Robinson R44 Series Helicopters

## AIRWORTHINESS DIRECTIVE

**AD/R44/14**

**Wire Harness and Fuel Line Chafing**

**Figure 1**

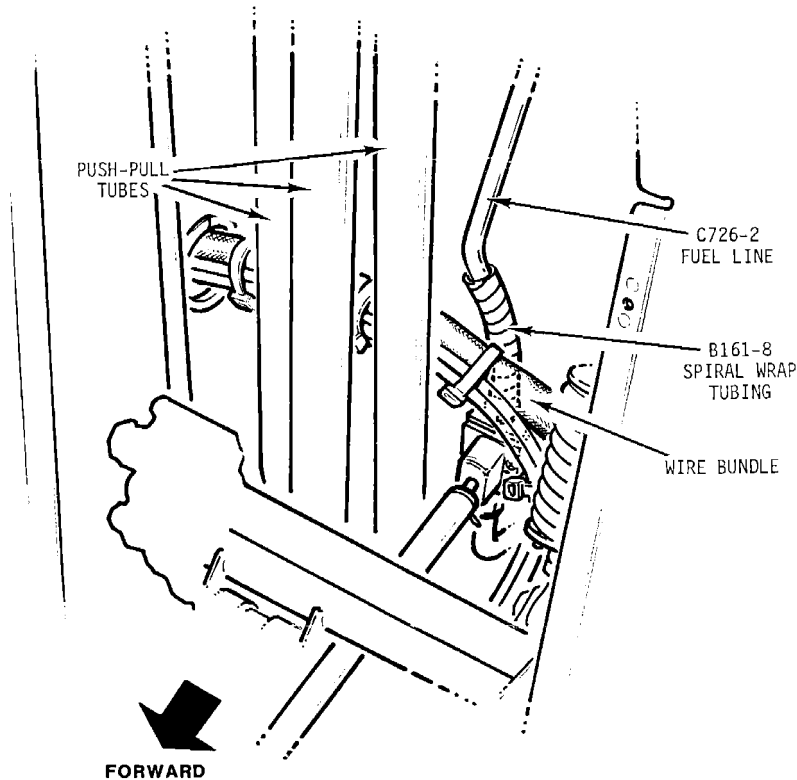
- Requirement:
1. Accomplish the following actions to prevent contact between the wire harness and the fuel line assembly:
    - a. Remove the cover, part number (P/N) C474-1, from between the rear seatbacks.
    - b. Inspect the wire harness, P/N C059, and the fuel line assembly, P/N C726-2, above the fuel shutoff valve for contact. If the wire harness contacts the fuel line assembly, inspect for chafing.
    - c. If chafing has occurred between the wire harness and the fuel line assembly, replace the fuel line with an airworthy fuel line assembly. Torque the fuel line nuts to 12.4-14.7 Nm (110-130 in-lbs). Verify that clearance exists between the fuel line assembly and the wire harness.
    - d. Install a 75 mm (3 in) section of spiral wrap tubing, P/N B161-8, on the fuel line assembly as shown in Figure 1. Push the spiral wrap tubing down until it is against the fuel line fitting.
